To:	Teri Camery (CBJ)	Date:	August 10, 2021
c:	Alix Pierce (CBJ)	Memo No.:	2
From:	Rita Kors-Olthof, Vladislav Roujanski, Shirley McCuaig	File:	704-ENG.EARC03168-01
Subject:	Responses to Public Comments Arising from Issued-for-Review Report (3 rd Draft) and Landslide and Avalanche Hazard Public Meeting – July 21, 2021 Downtown Juneau Landslide and Avalanche Assessment

This technical memo addresses some of the comments and questions that arose from Tetra Tech's Issued-for-Review (3rd Draft) Report, Downtown Juneau Landslide and Avalanche Assessment, dated May 28, 2021, and the Landslide and Avalanche Hazard Public Meeting that took place on July 21, 2021.

Figure 1: Excerpts from Figure 2.2c Avalanche Path Mapping Detail (left) and Figure 2.3a Avalanche Hazard Designation Mapping Overview (right).

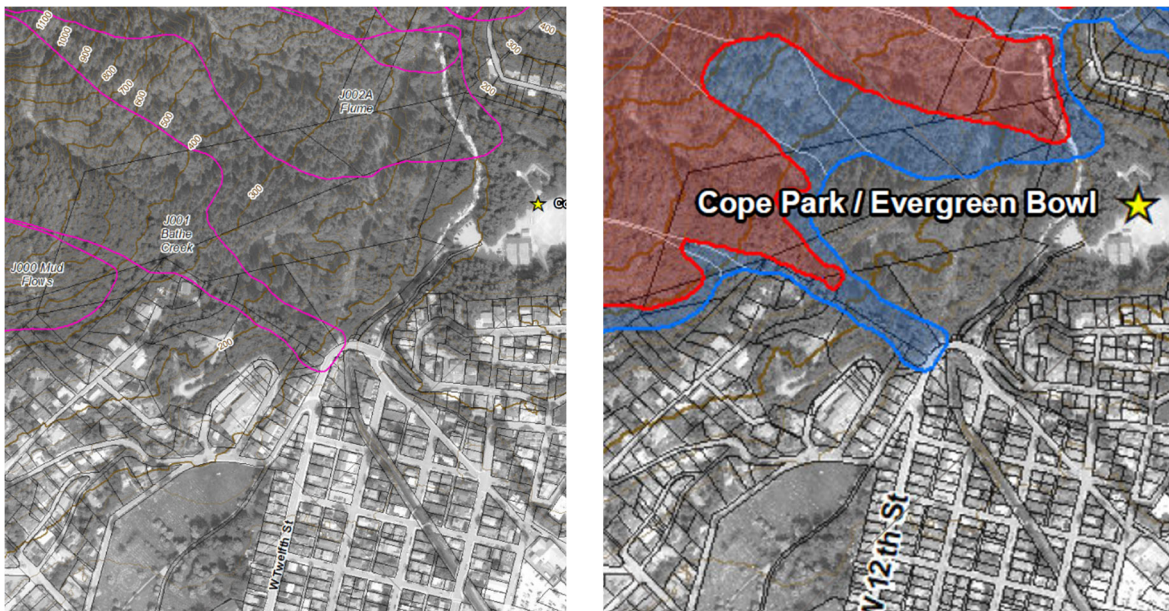
6. **Question/Comment:** The mapped boundaries [of the Severe hazard zone] are noted to be irregular, with curlicues and projections on the [east] side that do not resemble the mapped lobate avalanche boundaries, which may better define the landslide hazard area.

Response: See response to Item 3 above regarding the irregular “curlicues and “projections.” Bathe Creek is an example of where adjacent terrain units affect the shape of this terrain unit. In general, because the processes are not the same, avalanche path boundaries should not be expected to match landslide hazard boundaries. Compare the excerpts from the avalanche path and hazard mapping in Figures 2.2c and 2.3a (Figure 1 below) with the surficial geology and major gully features in Figures 1.3b and 1.5b (Figure 2 below). The boundaries of wet avalanches might sometimes approximate the boundaries of debris flows in the same terrain feature, a resemblance that would necessarily depend on the size and mobility of each event. In this case, they could be similar but not identical.

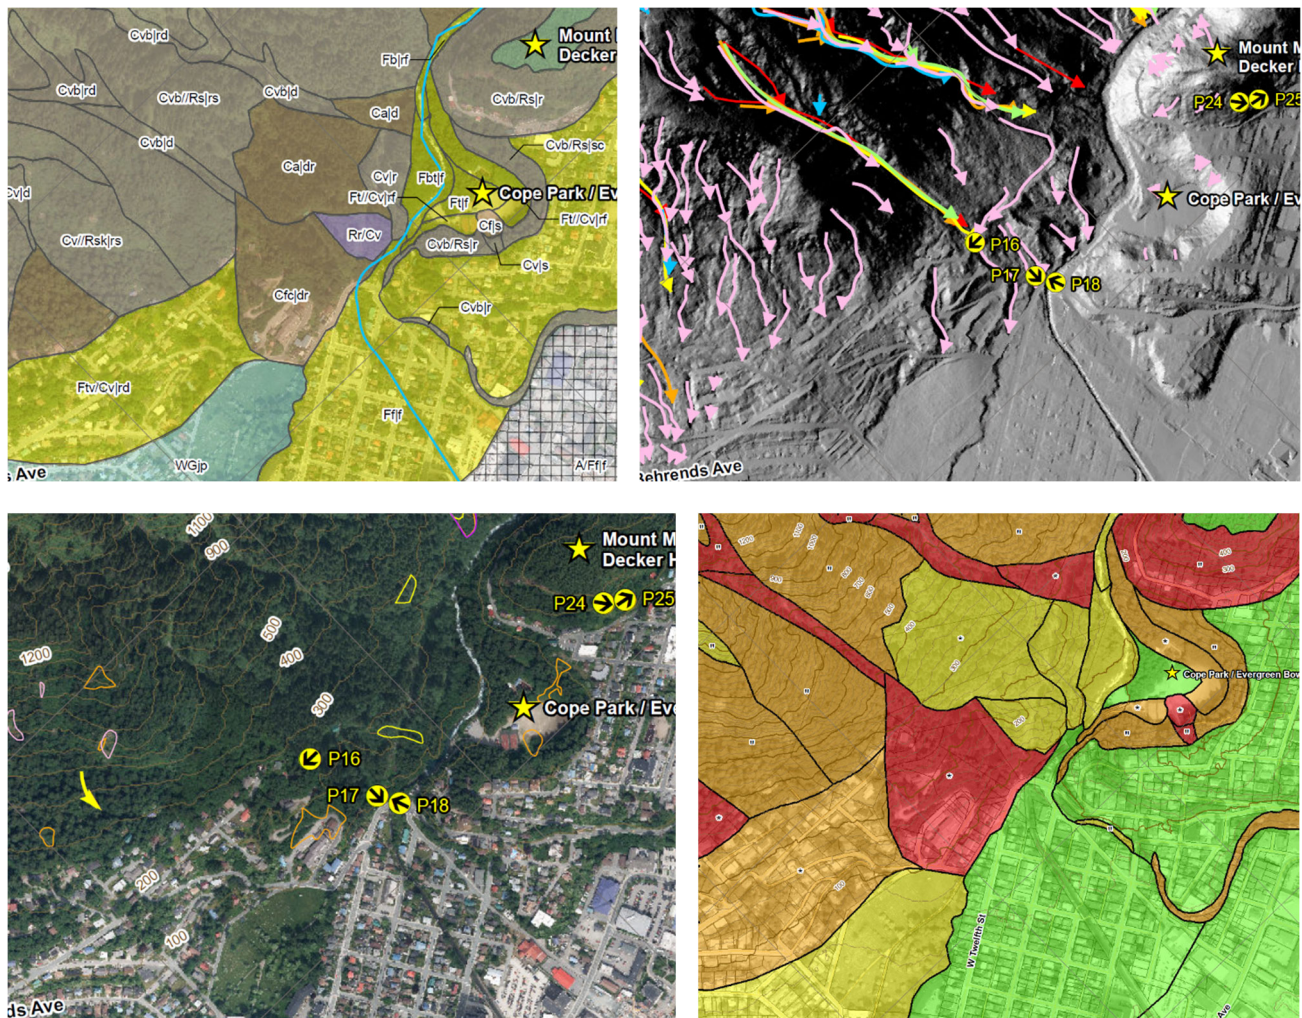
3. **Question/Comment:** Mapping polygons appear oddly-shaped, not corresponding to the lobate flow features or runouts expected in areas without strong topographic controls. Areas of criticism include “odd little pointy bits,” and abrupt changes in direction.

Compare the surficial geology and the major gully features shown in excerpts from Figures 1.3b and 1.5b (top left and top right in Figure 2 below). In the case of Bathe Creek, the shape of the Severe area reflects the shape of the cone/fan and the upslope gully that is the source of the debris, as shown below in the excerpt from Figure 1.6c (bottom right in Figure 2). Finally, even though the fan itself only displays occasional activity (remobilization of old debris flow material), as shown in the excerpt from Figure 1.4b (bottom left in Figure 2), the debris flows originating from upslope govern the hazard designation, as they are what has formed the fan and what will continue to do so in the future.

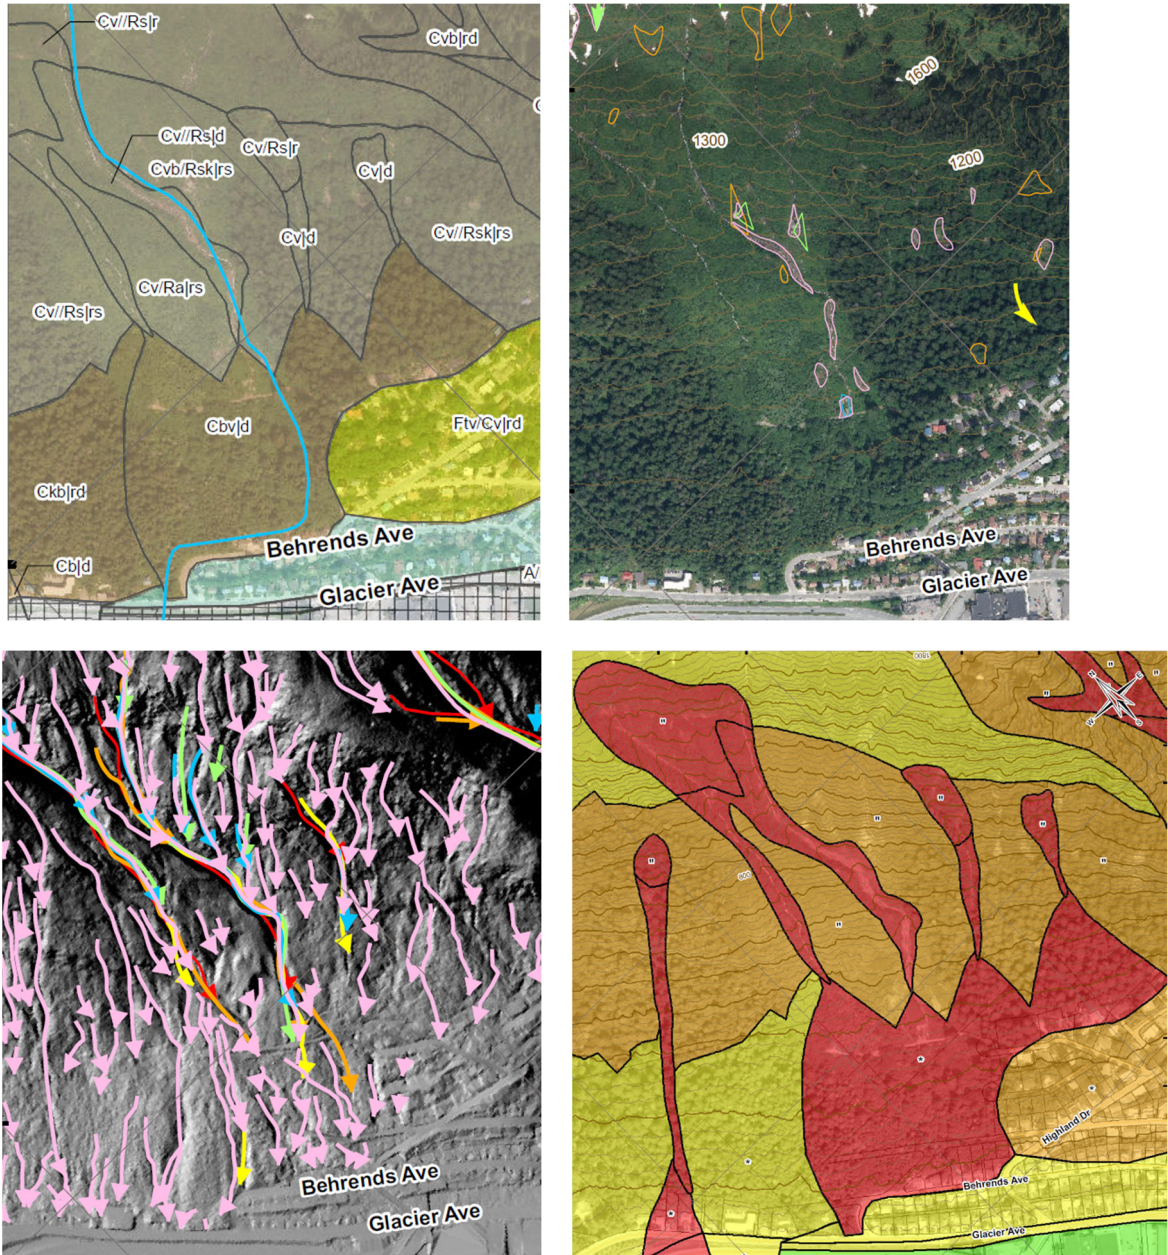
9. **Question/Comment:** The [west] side of the Severe hazard zone is noted to include a large area of colluvium in the Irwin Street to Highlands area, despite no recorded slide history since houses were built there. If the Swanston (1972) study is intended to support the Severe designation, maps and quotes from that study should be included in the report.

Response: The basis for the Severe hazard designation is not Swanston’s report, but rather Tetra Tech’s independent determination of the characteristics of the terrain units based on surficial geology mapping, historical air photo record analysis of slope movement features and gully erosion features, as well as incident reports and field observations. See also responses to Items 1 and 4 above. Specific to the Severe areas mapped in this part of the study area (Figure 1.6b and 1.6c), these are all colluvial areas (Figure 1.3b) that receive debris from several active gullies upslope (Figure 1.5b), including the previously mentioned Bathe Creek gully (see Figure 2 above), and several active gullies above Behrends Avenue and the west end of Highland Drive (see Figure 3 below). Several of the two dozen debris slides that occurred in various years in the immediate map area (Figure 1.4b) happened within gullies (compare top right and bottom left in Figure 3 below). The excerpt from Figure 1.4b (top right in Figure 3 below) is also a good example of an avalanche track (area with no trees) that does not correspond perfectly with landslide activity and location.
